RE: 8401 Firestone Lane NE

Permanent C.O. - Accepted Grading & Drainage Plans

Hydrology File: C17D013B3 Case # HYDR-2025-00128

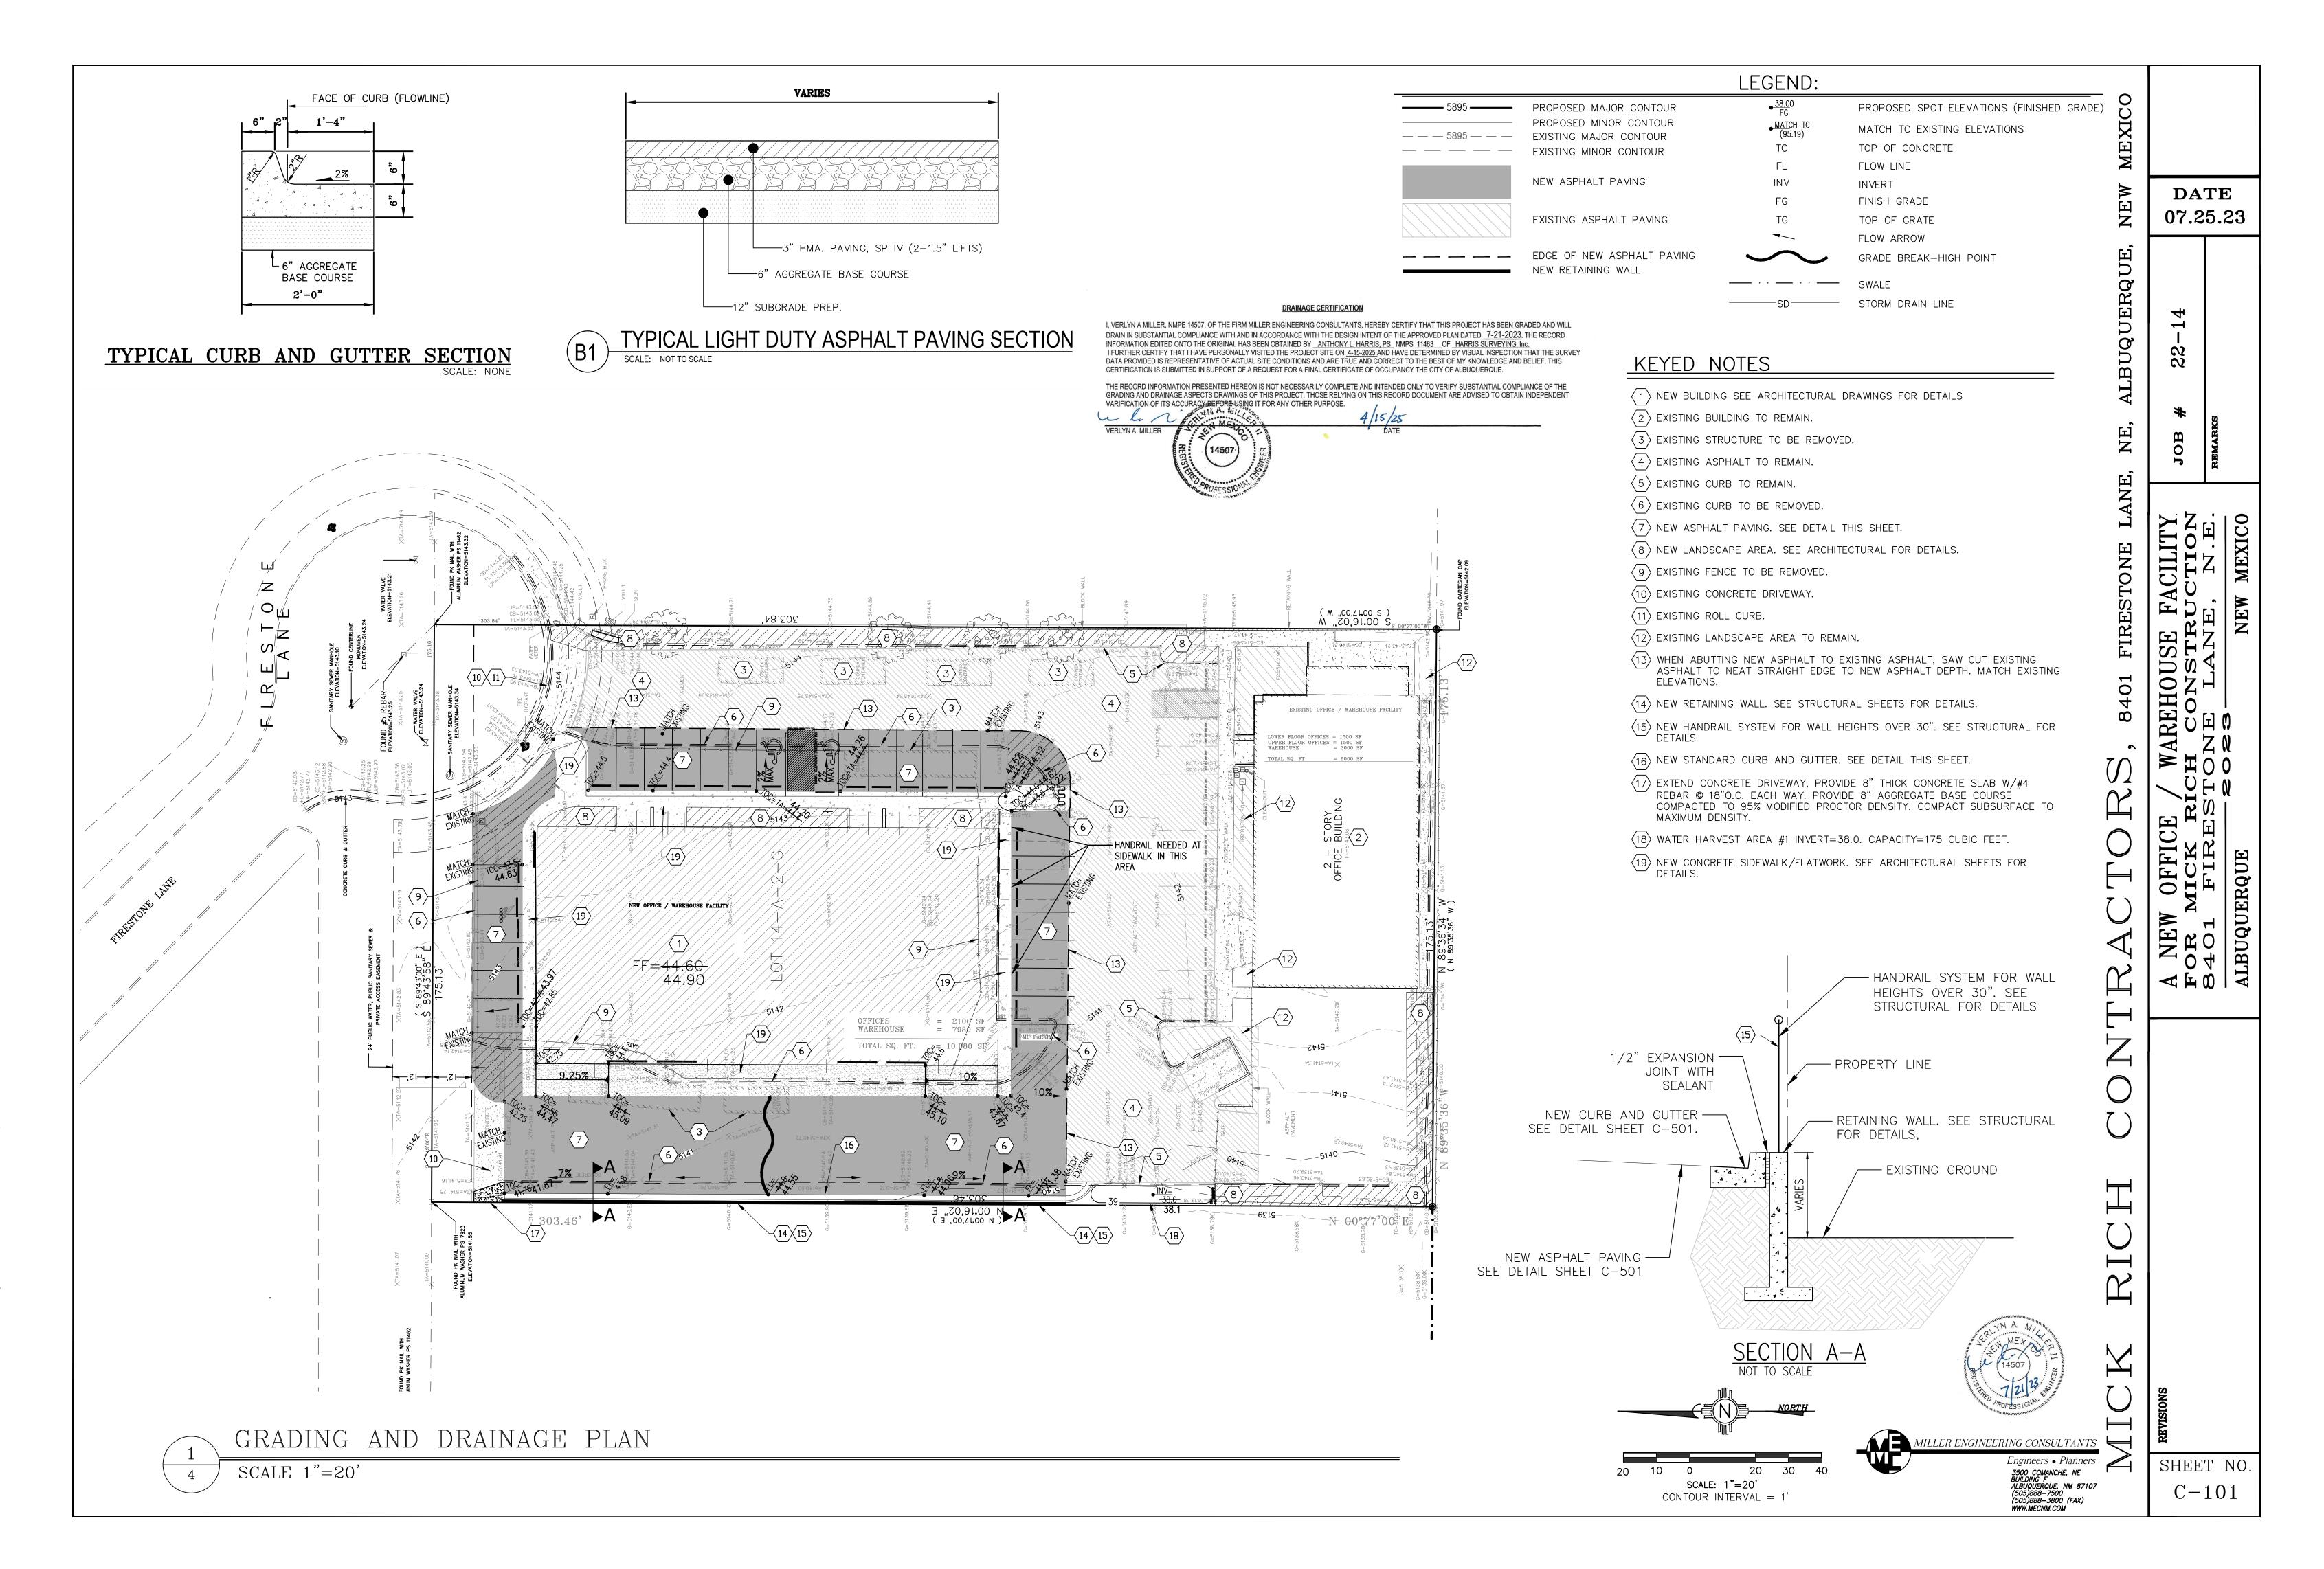
Based on the Certification received 04/16/2025 and site visit 4/25/2025, this certification is approved in support of Permanent Release of Occupancy by Hydrology.
